Sansui Europe Service Information

SSI-0004E

Models : - 9090, 8080

FIG. 1

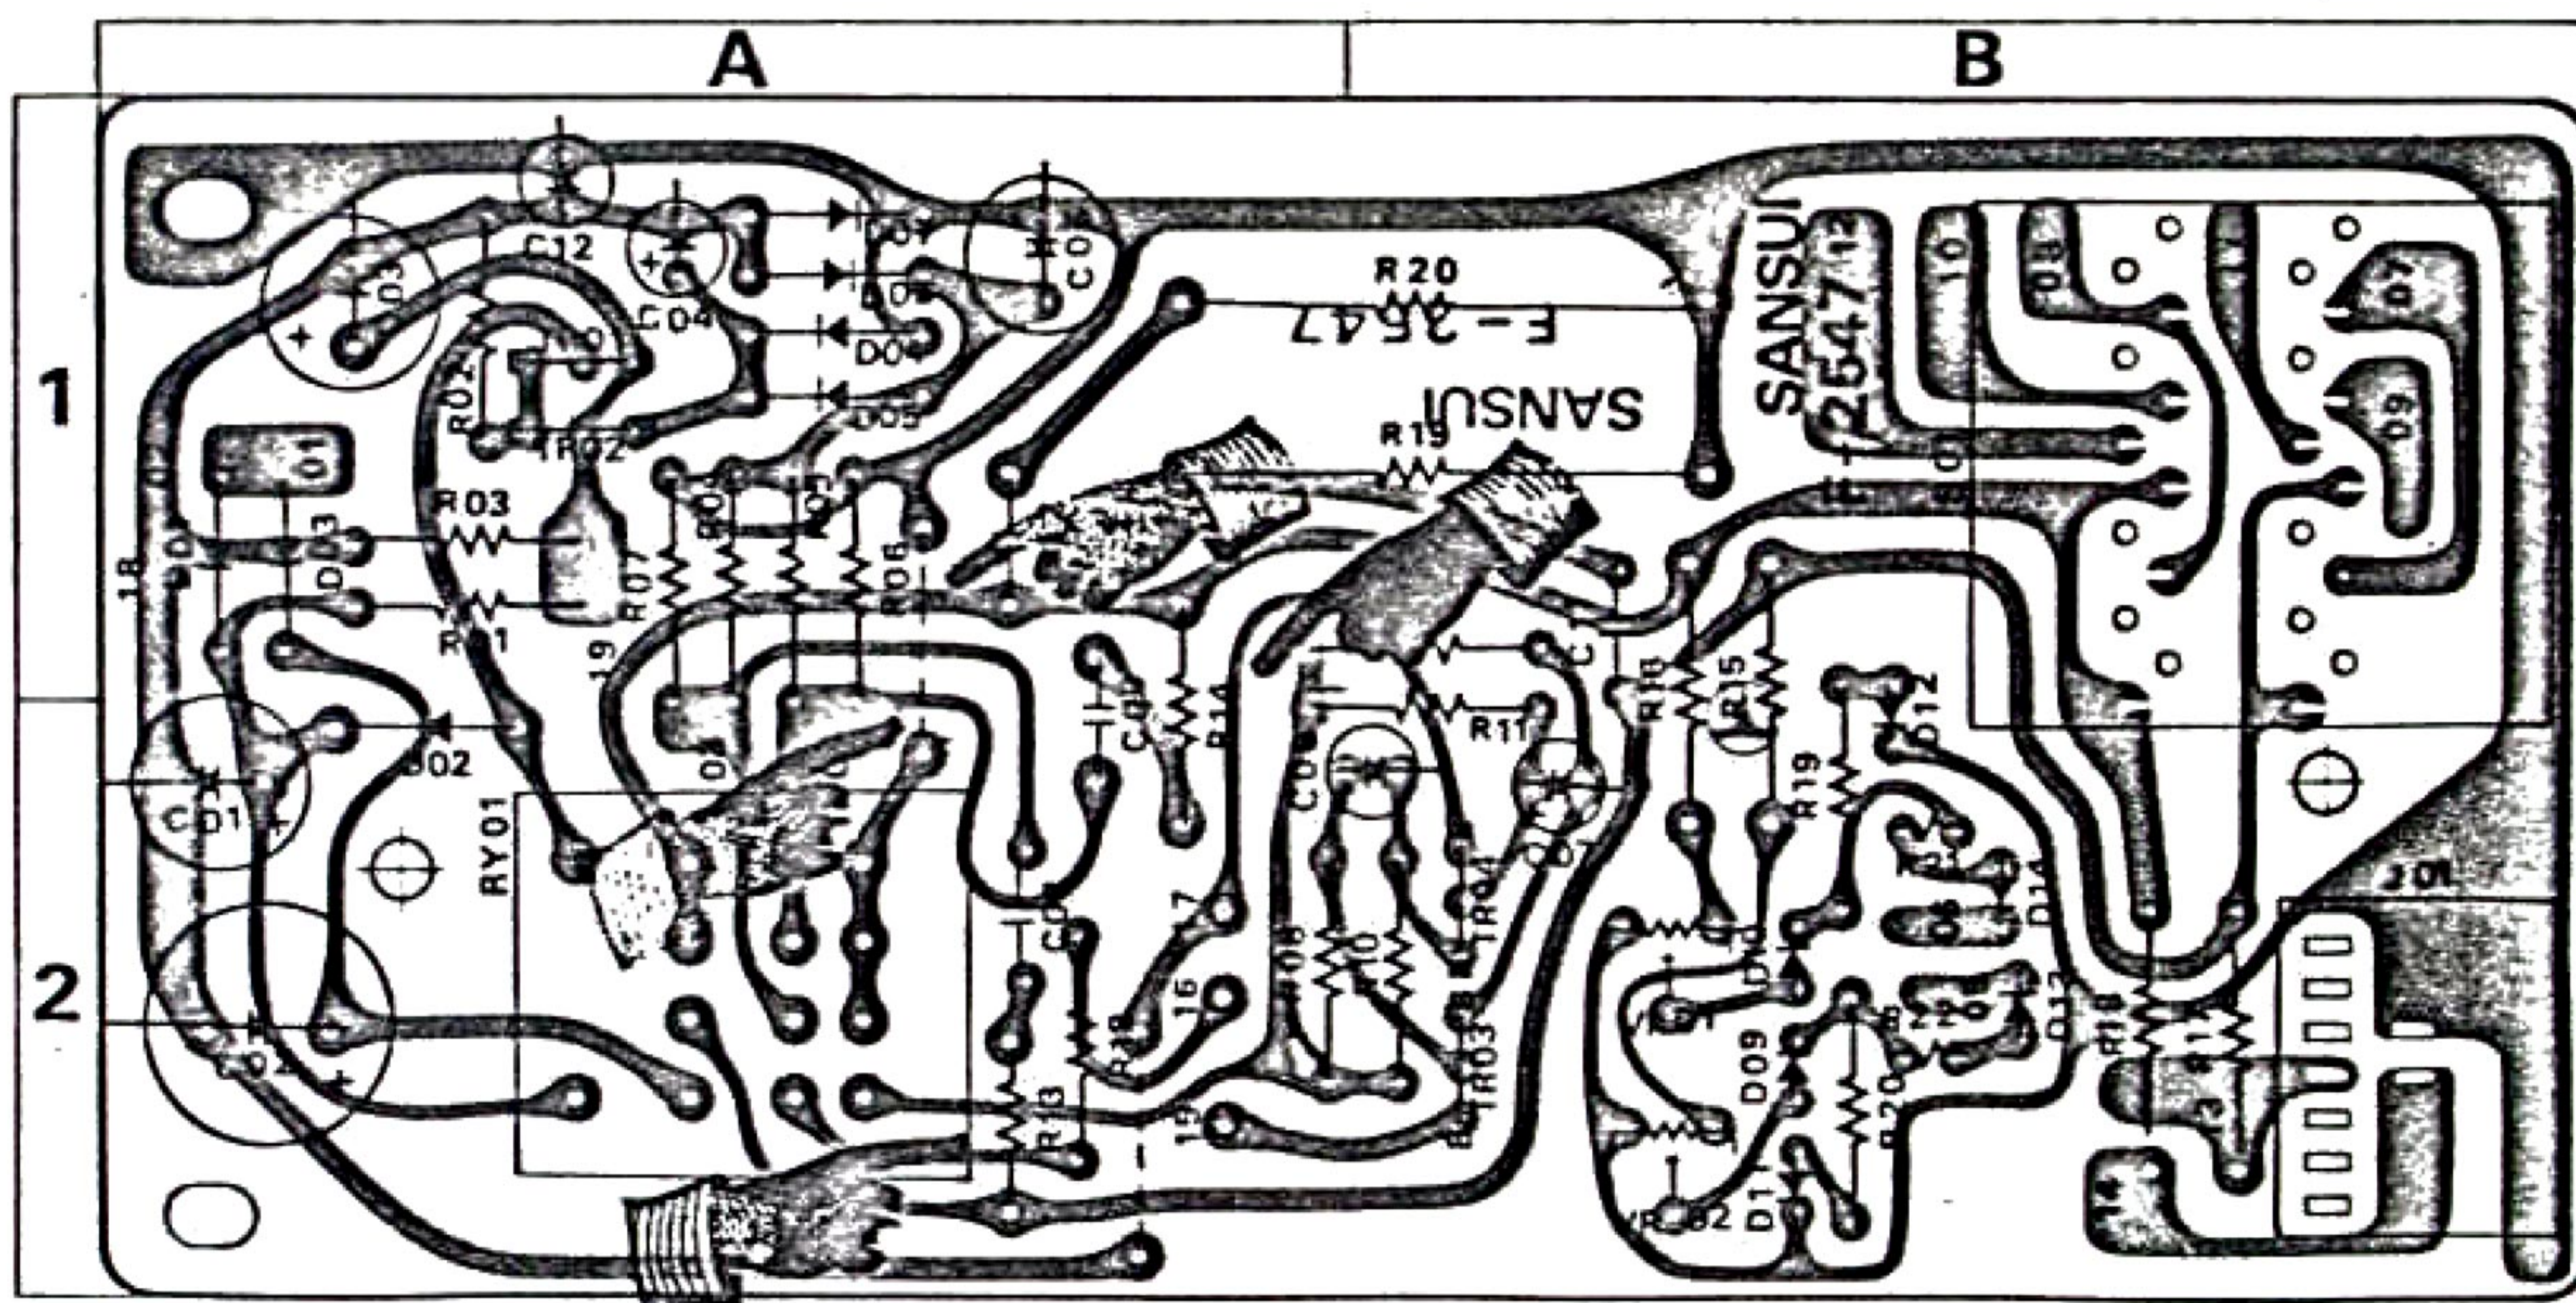
- Resistors R13 and R14, 10 Ohms have to be replaced by special fusing resistors of 4.7 Ohms 1/2 W. See fig. 1.
- The jumper connecting some relay contacts to earth, as shown in fig. 1, has to be removed.

FIG. 2

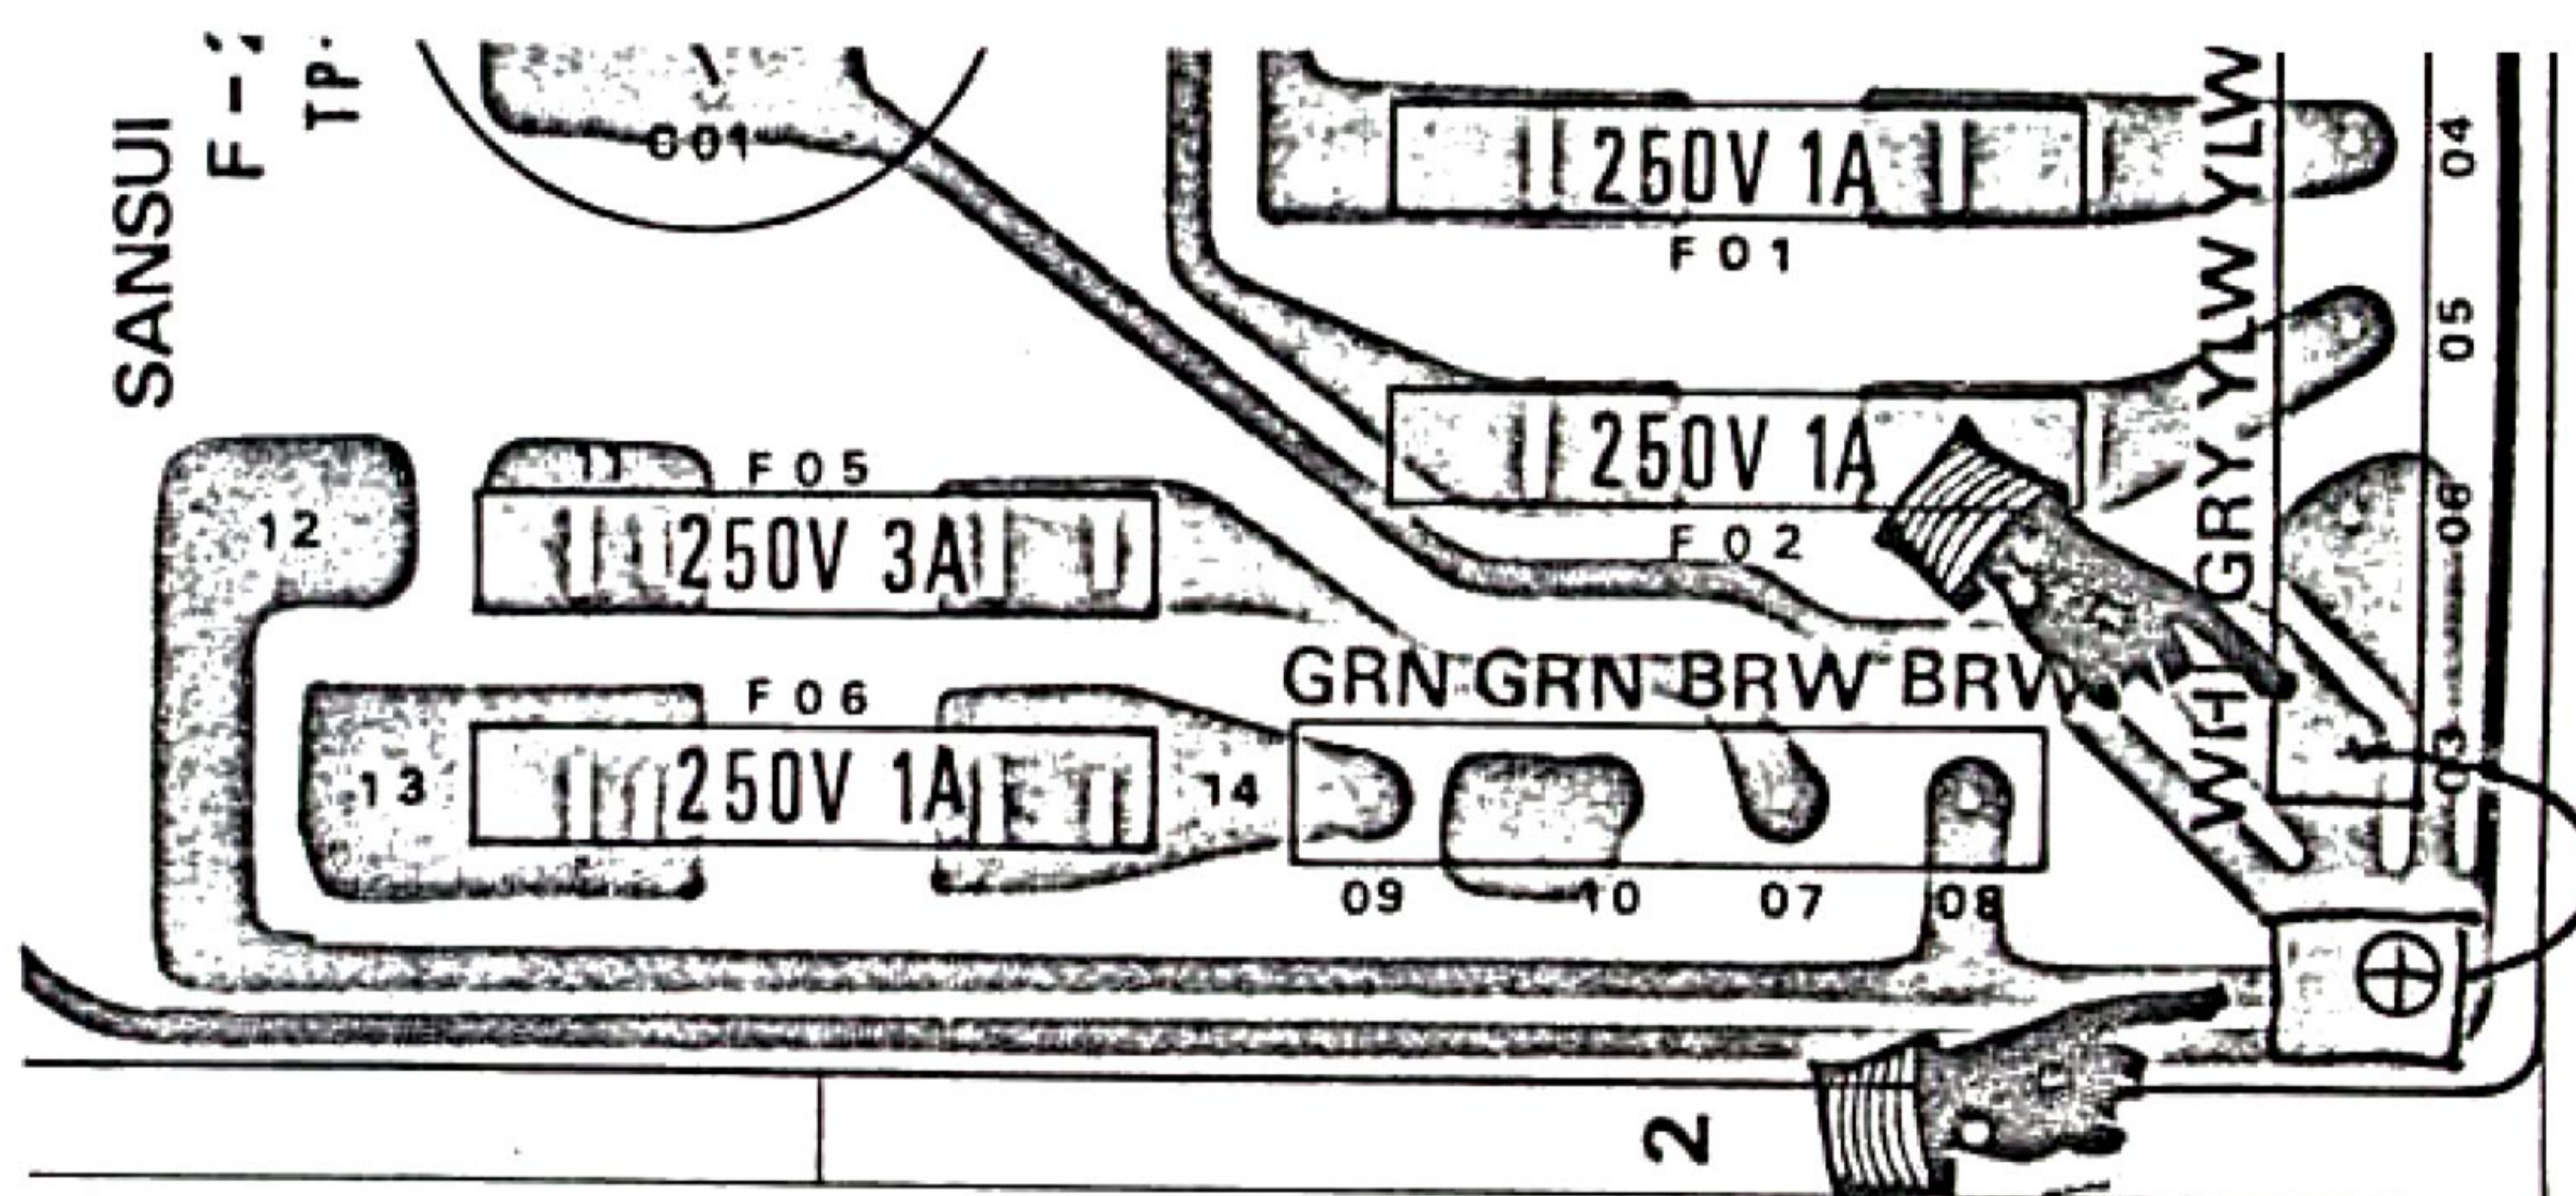
3. The earth contact on P.C.B. F-2546 can be ameliorated by soldering a piece of mesh-lead or any piece of thick, well-conducting wire, from point 03 (or 06) to the adjacent earth lug, as shown in fig. 2.

FIG. 3

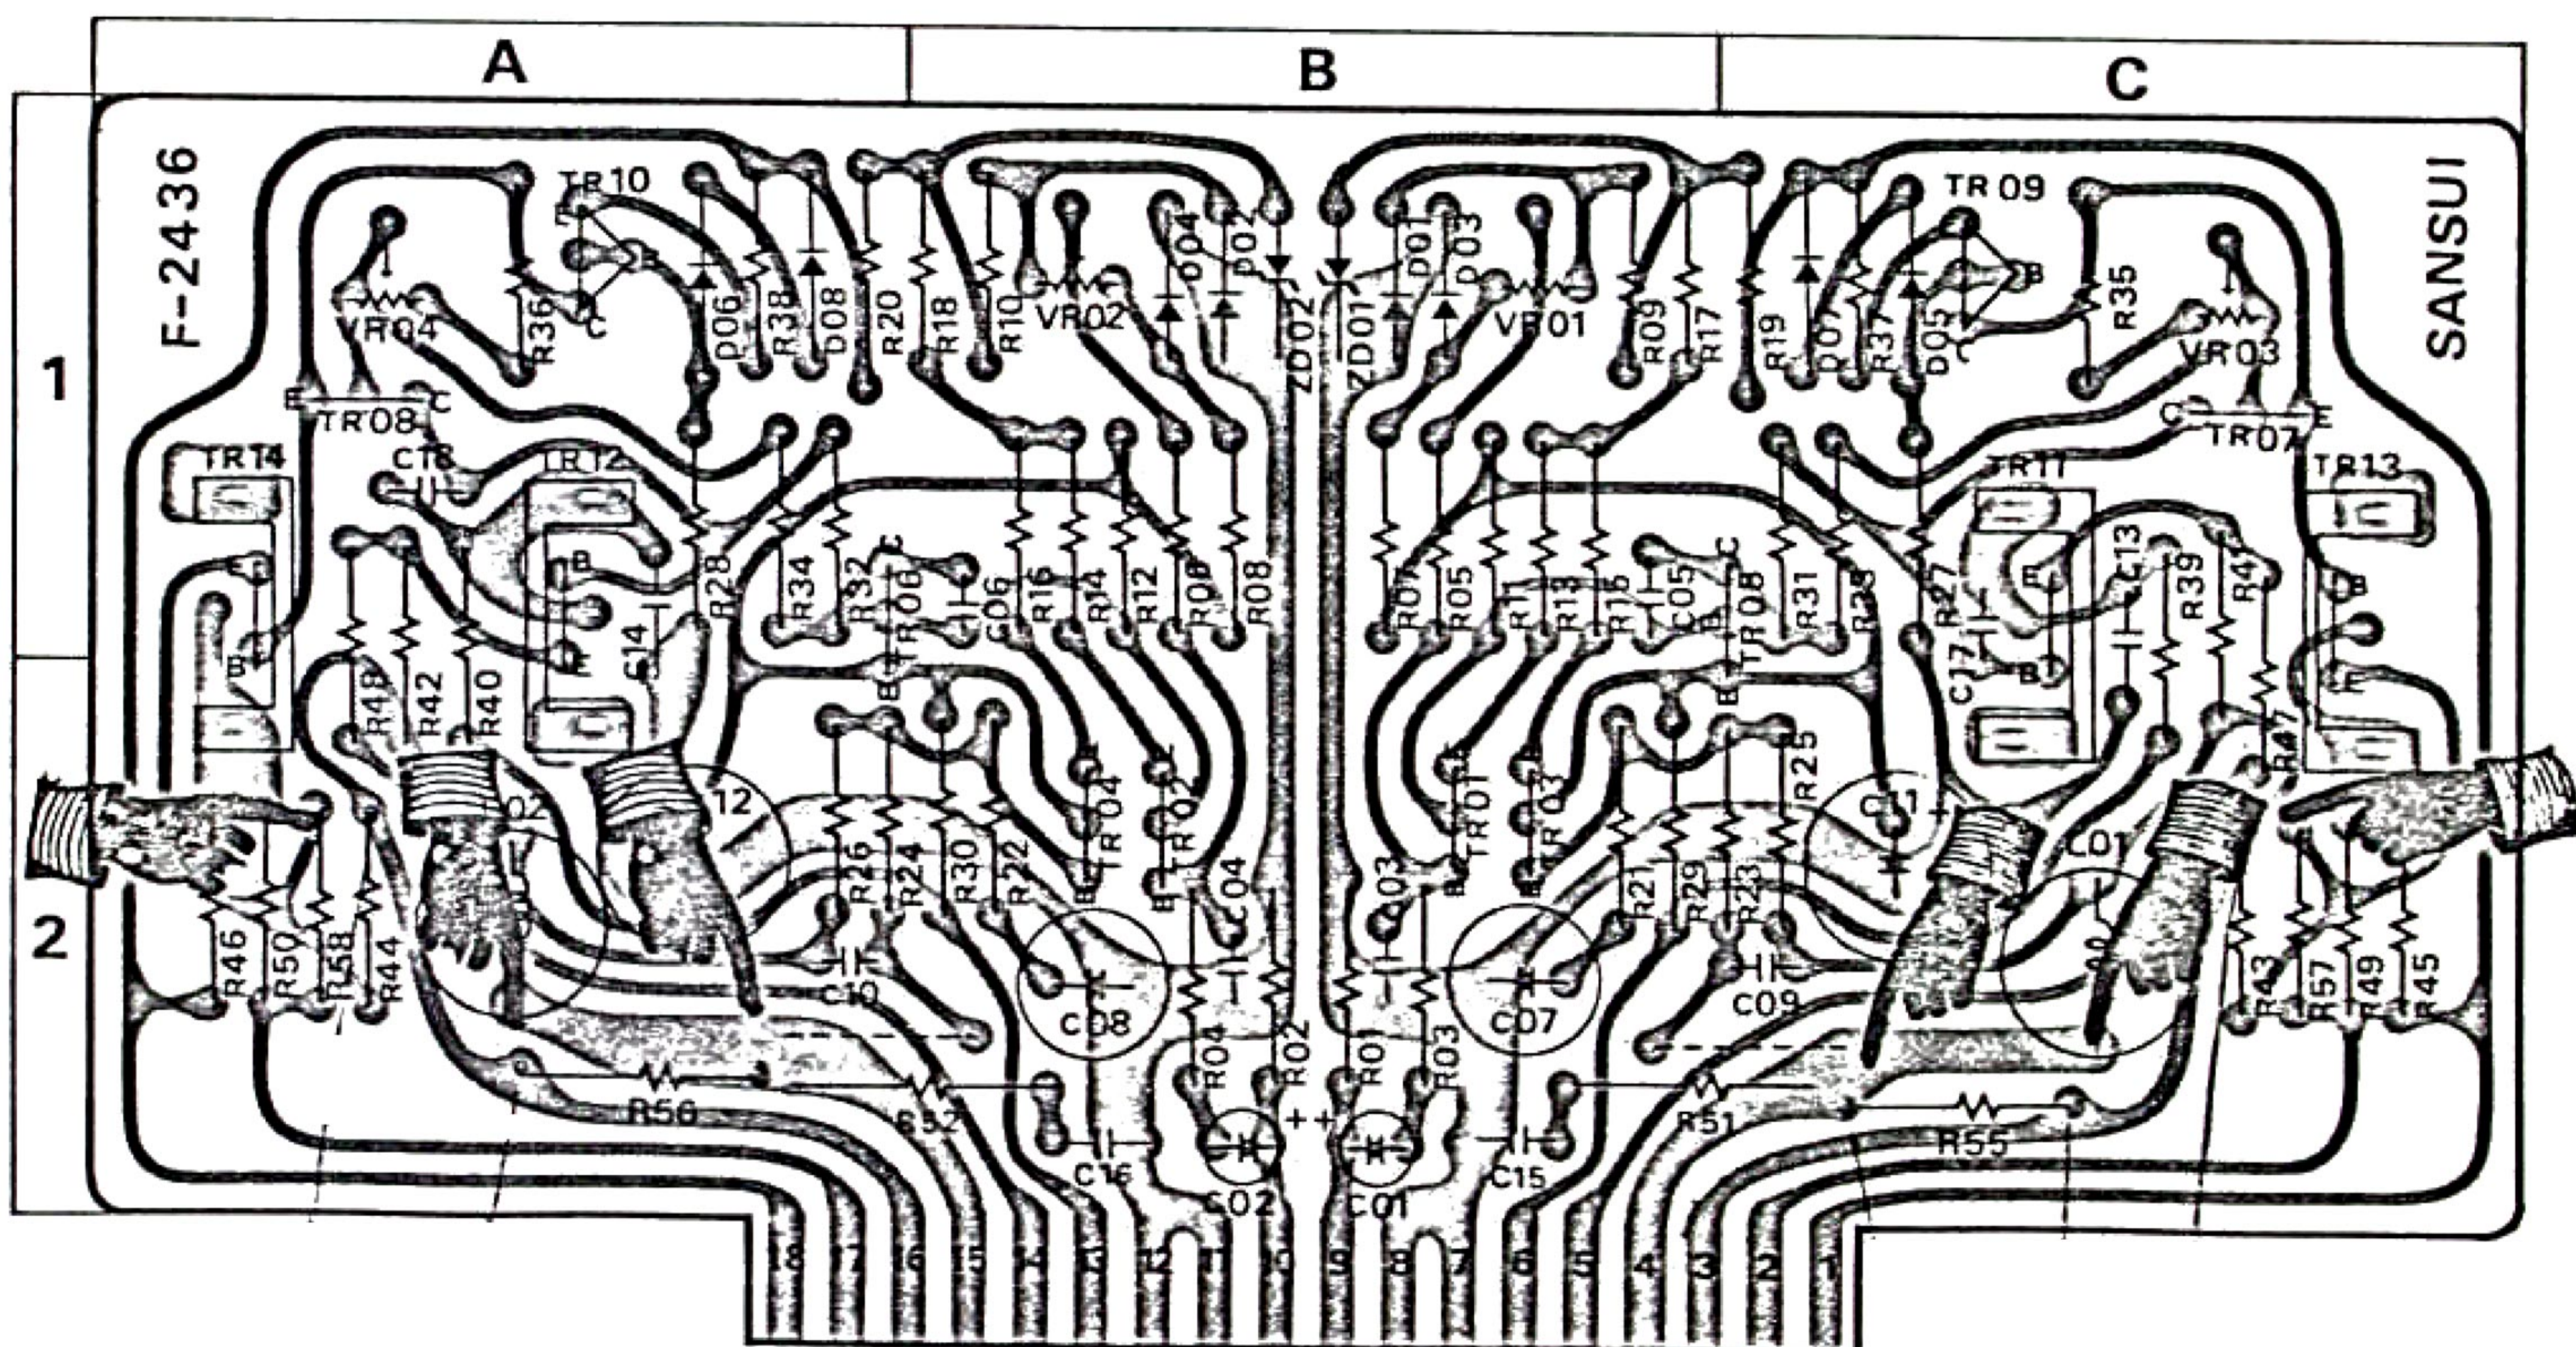
- Connect one wired-in fuse from point M on P.C.B. F-2436-1 (See fig. 3) to point N or to point O, depending upon the position of resistor R44.

- Connect one wired-in fuse from point P on P.C.B. F-2436-1 (See Fig. 3) to point Q or to point R, depending upon the position of resistor R43.
